SSC Service Bulletin

no. 82-272

MODELS AFFECTED: MCL60 PA DECK, ALL RANGES

PRODUCTION CHANGES:

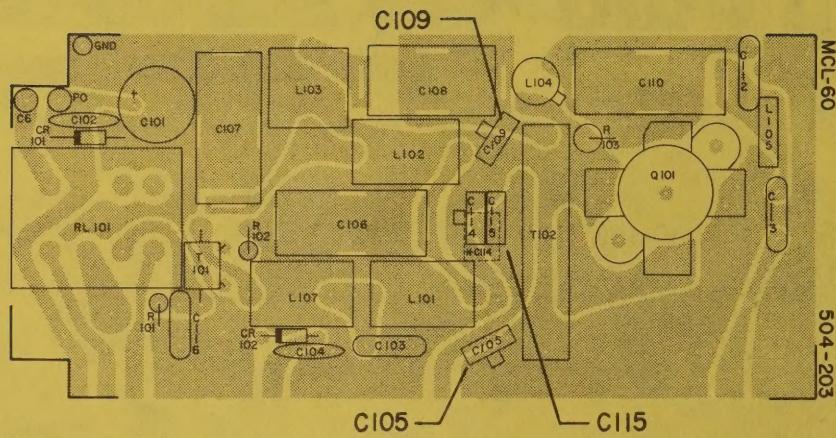
On Range C PA decks capacitor C115 has been deleted.

POST SEPT. 1982 PRODUCTION:
DELETE C115.
CHANGE C114 TO .01 μ F CERAMIC CHIP (NPO)

A & B RANGE

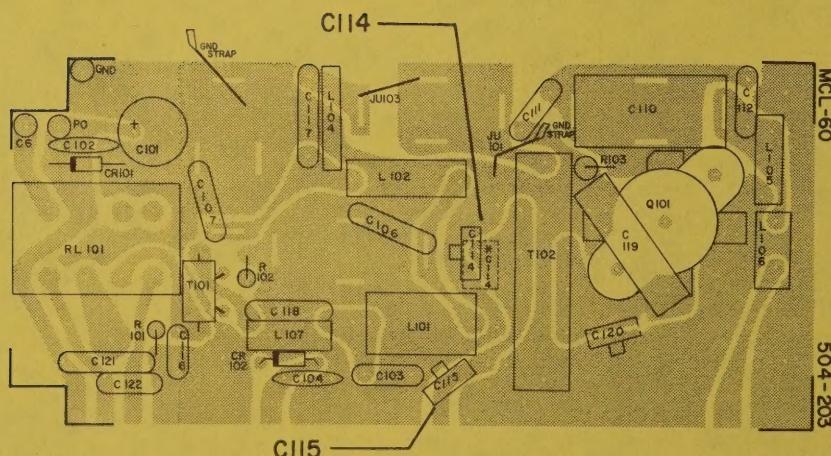
On Range A & B PA decks capacitors C105, C109, and C115 have been deleted.

On all PA deck ranges capacitor C114 has been changed to a .01mf NPO ceramic chip cap (Regency Part # 1540-0103-683).

POST SEPT. 1982 PRODUCTION:—
DELETE C105, C109, C115.
CHANGE C114 TO .01 μ F CERAMIC CHIP (NPO)
